REVIEW COMMENTS

FILE #RP-95-200

TITLE HEADING: Replat & Site Plan Review -
Cimmaron North Minor Subdivision

LOCATION: 24 1/2 & F Roads

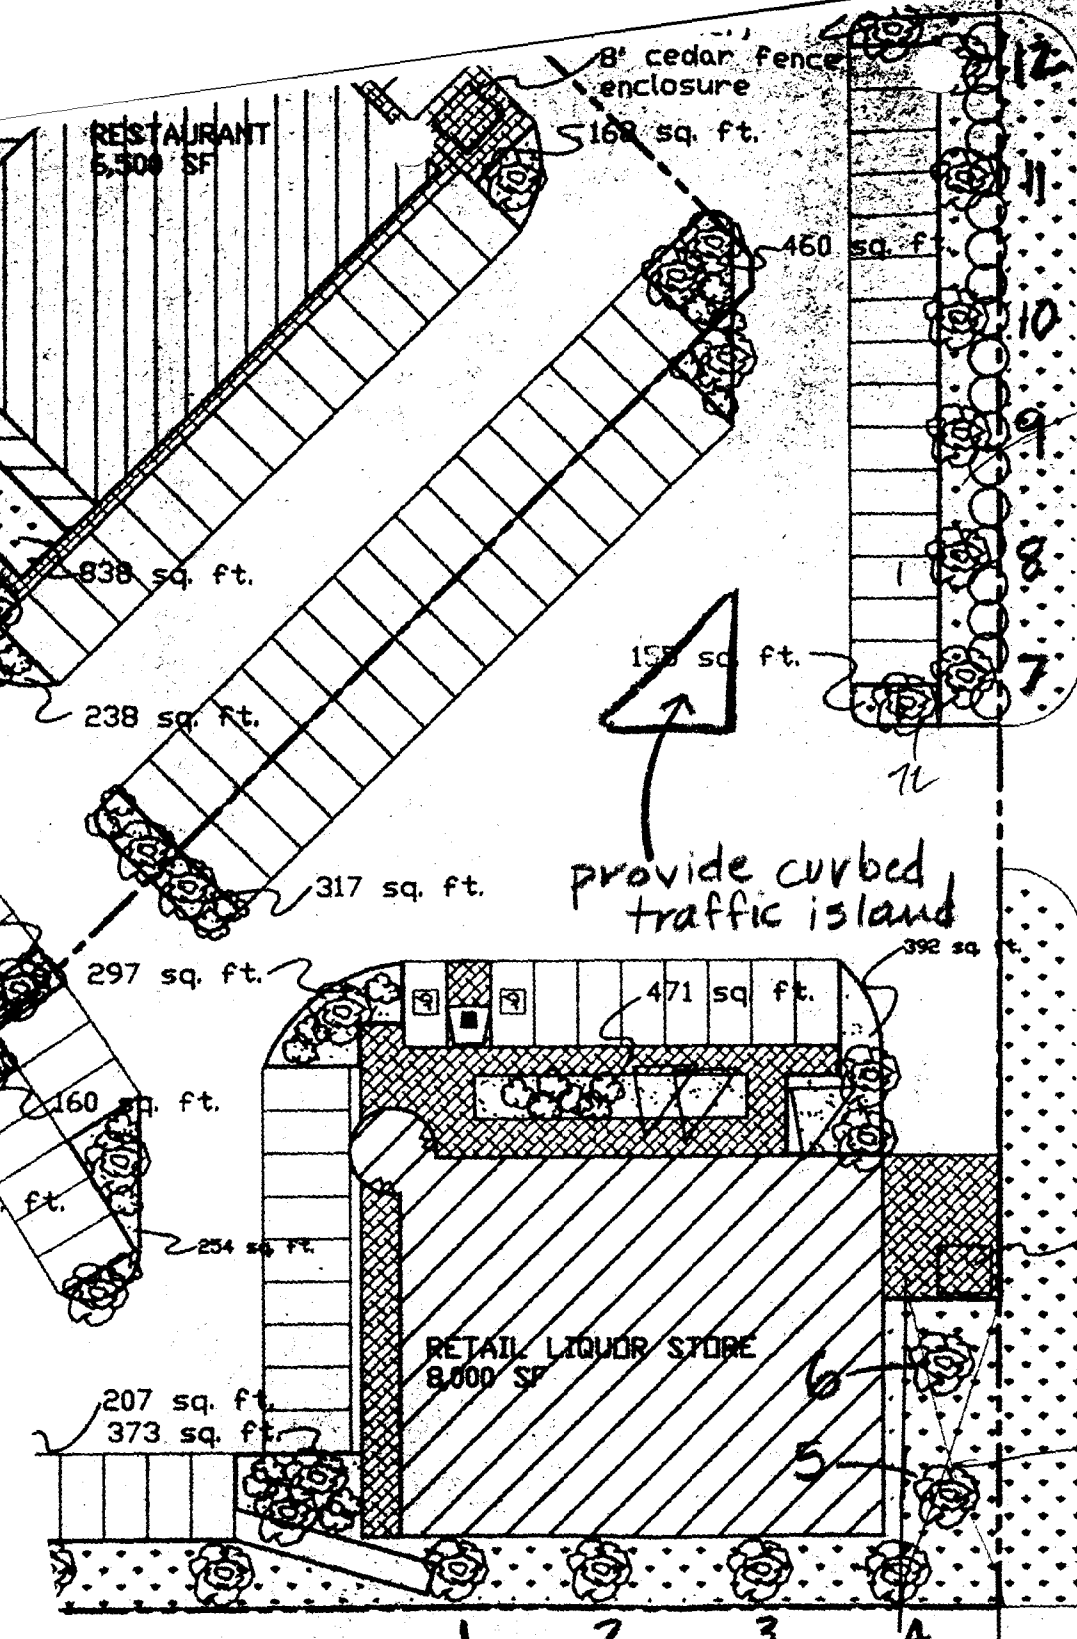
Narrative states that there will be two access points on 24-1/2 Road and two-way circulation on the site, yet plan indicates 3 access points, one of which is one-way?

Amount of parking is adequate as shown and as phased; however, changes may need to be made per comments below for Landscape Plan.

Lighting has several gaps that could be filled if landscaped/parking islands were added in the large vacant triangular areas and lights were placed on the islands (see red-lined plan). Also, a building light on the northwest facade of the restaurant may help fill the gap in lighting on that side of the building. Such islands would also help facilitate better traffic flow in these areas that are otherwise a "free-for-all".

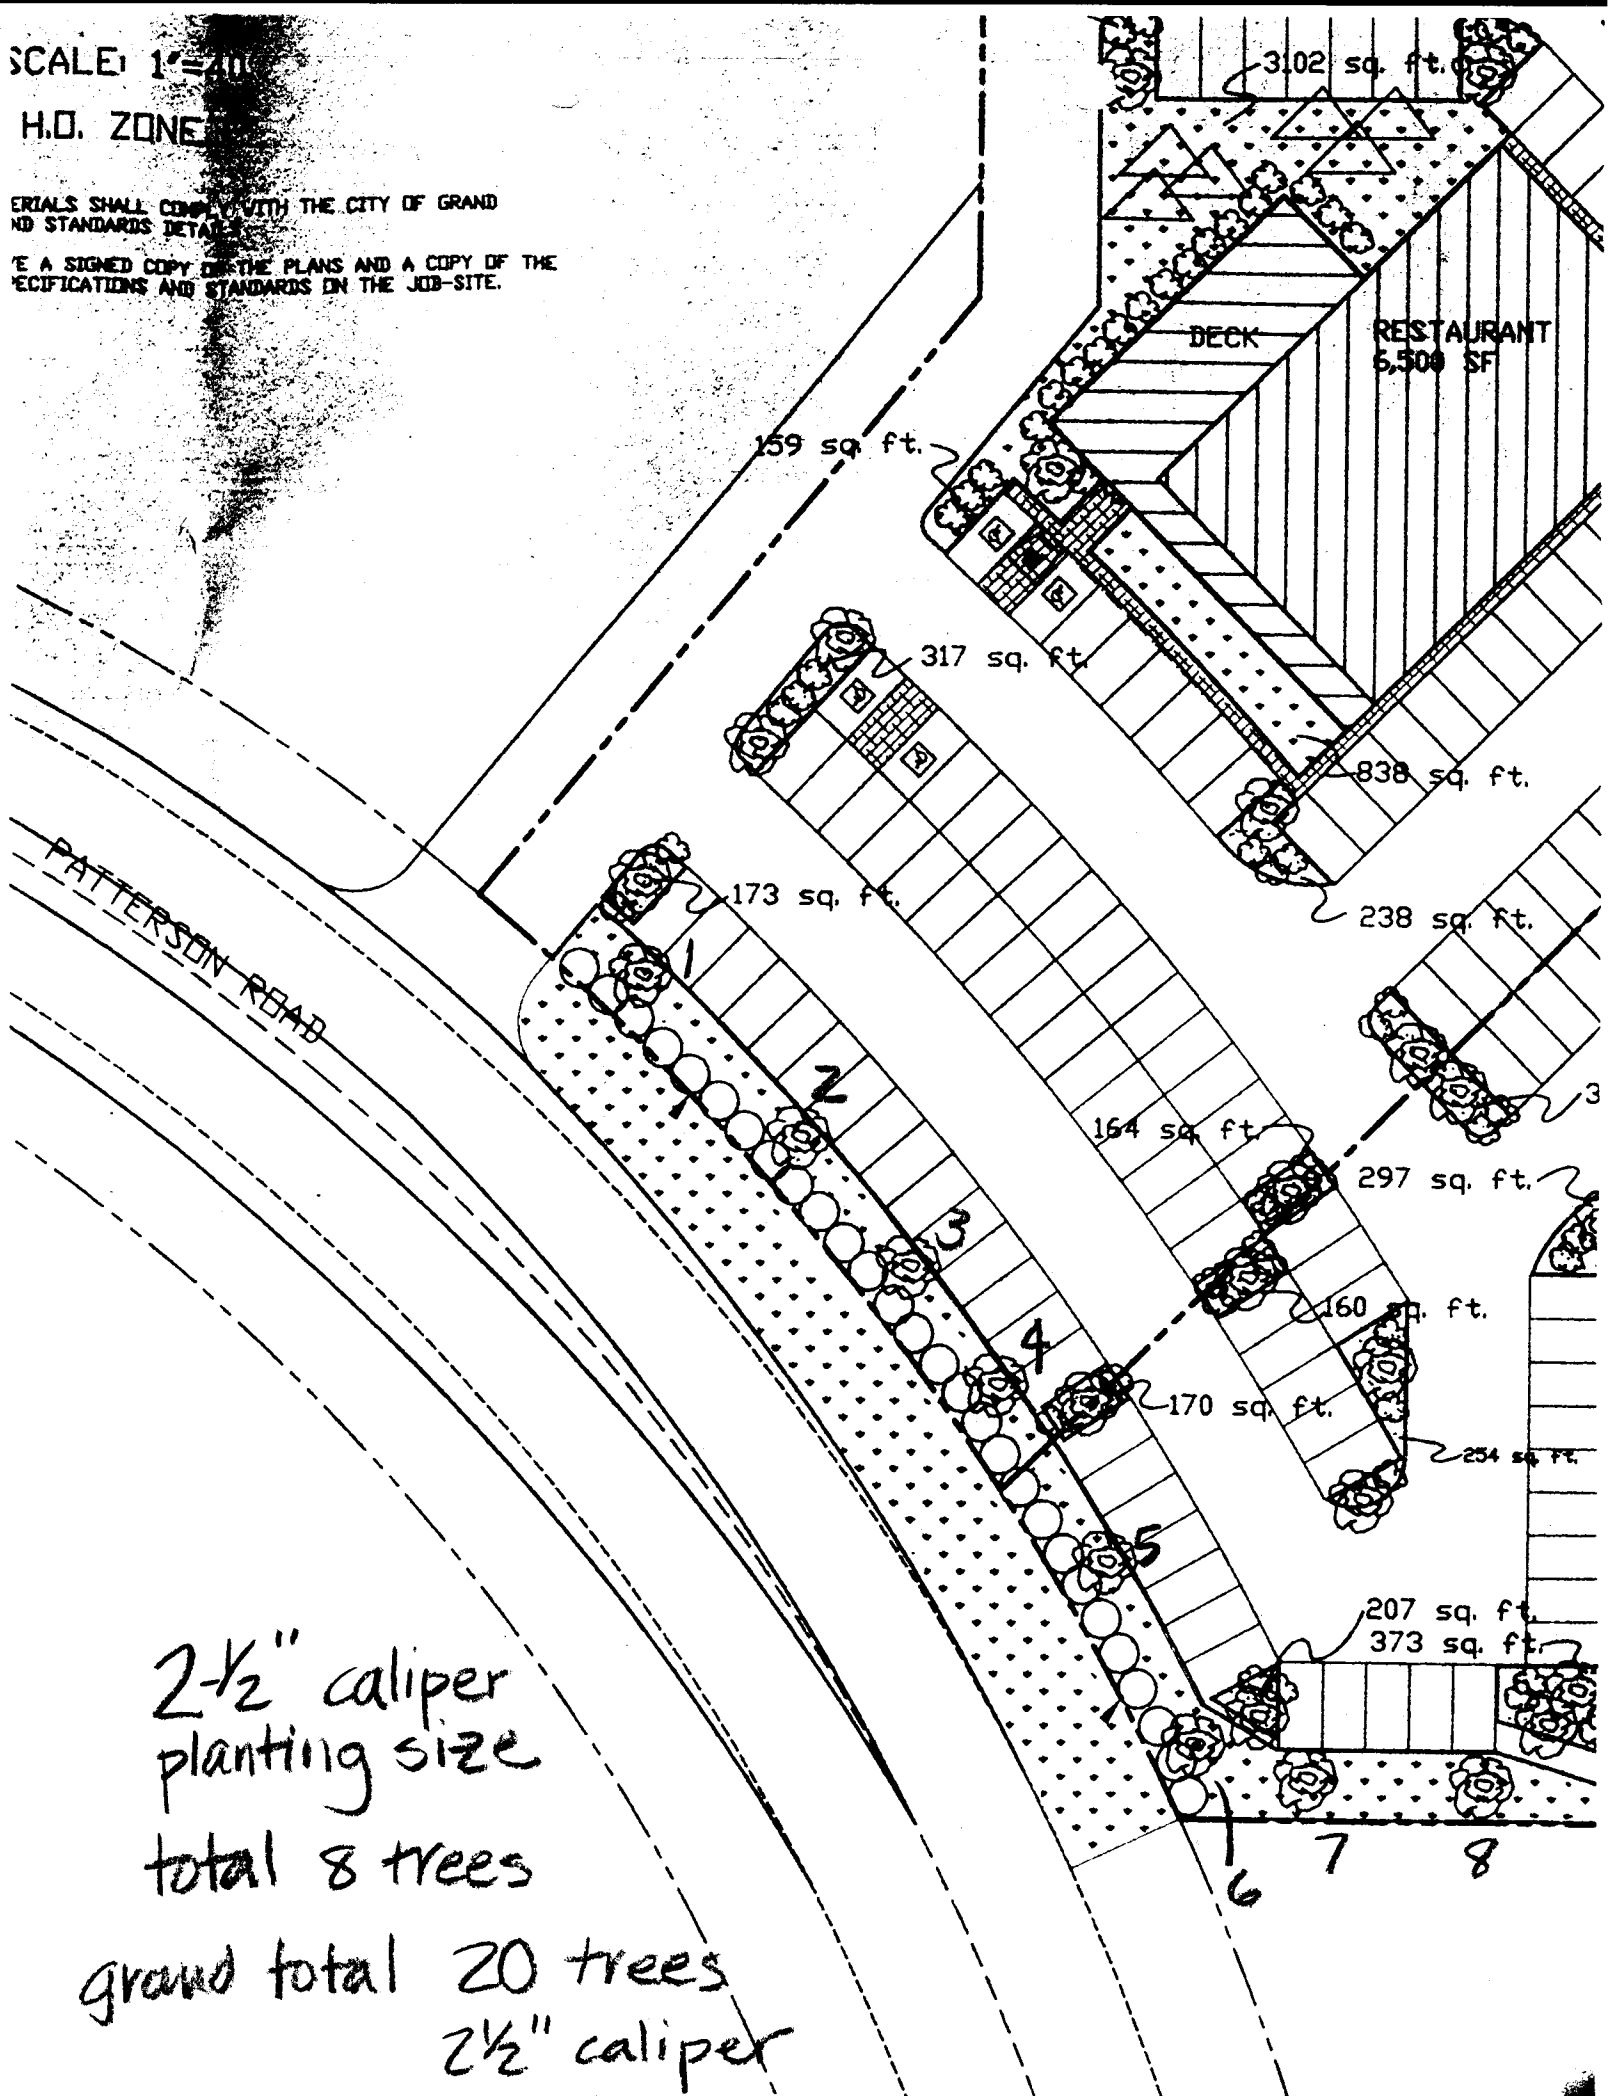
The Highway Oriented (HO) zone requires that a minimum of seventy-five percent (75%) of the required front yard setback be landscaped. This has not been met in the 25-foot front yard setback along 24-1/2.

The landscape plan must distinguish which species of trees will be placed where rather than lumping all trees under one symbol -- this is primarily to be able to review placement of coniferous trees so as not block sight distance.

Minimum planting size of coniferous trees is 6 feet rather than the 1-1/2" caliper indicated on the plan.

Per our phone conversation of 1/8/96, staff has the following comments regarding the landscape/site plan (refer to attached drawing for clarification):

1. Do not need to provide a physical triangle at the northern 24-1/2 Road entrance.
2. For circulation purposes, do need to provide the a physical triangle (no striping) at the southerly 24-1/2 Road entrance. The southern curb of the triangle should align with the northerly curb of the southern entrance.
3. In lieu of meeting the landscape requirement for 24-1/2 Road setback (75% of 15'), the Administrator has determined that the requirement may be varied if the perimeter trees provided are larger at planting than the minimum required planting size. Please provide 2-1/2" caliper trees along the perimter rather than 1-1/2" caliper trees. Please revise landscape plan to indicate this requirement.
